STAFF REPORT-Amended

Case #08-17: SITE PLAN REVIEW

899 Pleasant Street/ES Foster Street
Southeastern New England Dental

Site Plan Review : 899 PLEASANT ST NEW BEDFORD
Owner: SOUTHEASTERN NEW ENGLAND DENTAL GROUP, INC.
Developer: 899 PLEASANT, INC

1
C-2
DRIVEWAY CURB CUT
NOT TO SCALE

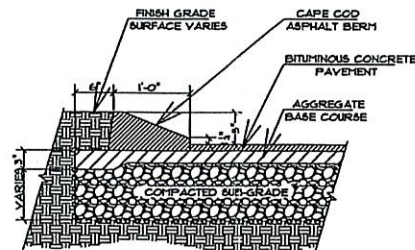
A. Lack of information on the plans to address the following issues.

Newly submitted plan C-2 provides a detailed drawing of the proposed driveway construction
